SUBJECT: Rear engine baffle assembly, P/N 600411-501, modification.

AFFECTED: MOONEY M20K, (Mooney 252),* S/N 25-1000 thru 25-1217
* (Only dual alternator equipped aircraft are affected.)

FIGURE 1

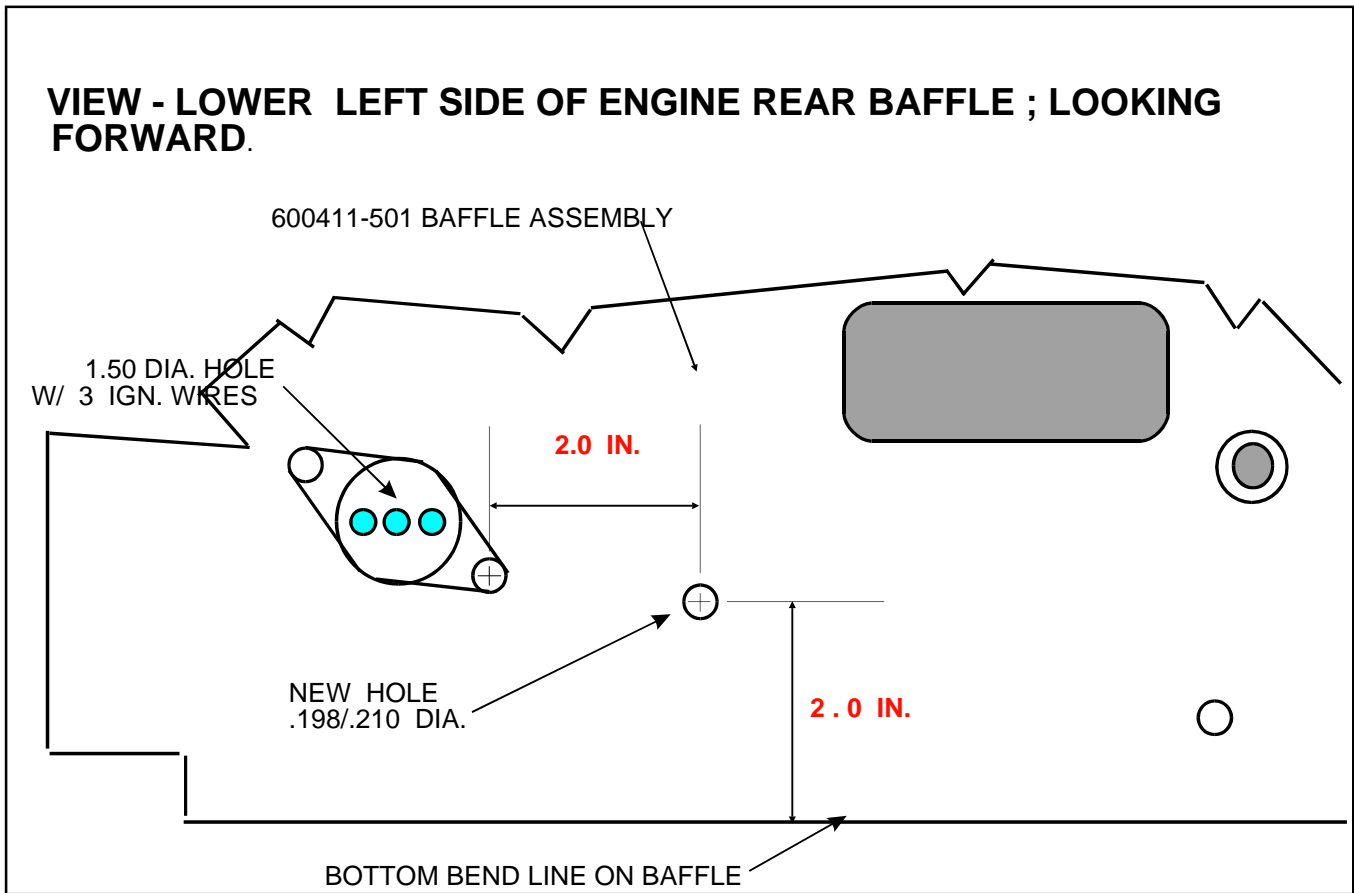
INTRODUCTION: There have been reports of the alternator output wire connector breaking at the terminal of the No. 2 alternator on MOONEY 252, TSIO360-MB1, engine installations. This is dependent upon how tight the No. 2 alternator output wire may be secured at various points. If desired, aircraft owners may elect to have this S I incorporated on any of the above S/N aircraft.

1. Remove upper cowling (lower cowling removal is optional) per S & M manual, Section 71-10-00.
2. Refer to Figure 1 to locate and drill the new hole (.198/.210 dia.) to be added to 600411-501 baffle assembly. New hole location does not have to be exactly to the dimensions shown on Figure 1. Deburr hole as needed.
3. Alternator output wire is routed along left diagonal engine mount w/existing clamps. Leave sufficient slack to allow coordinated movement between the alternator, baffle and the wire.
4. Clamp alternator output wire at new hole in rear engine baffle using MS21919DG5 clamp, AN3-5A, AN960-10 and MS21045-L3, bolt, washers and nut.
5. Check wire routing to insure freedom of movement with engine.
6. Enter compliance note into logbook and return aircraft to service.
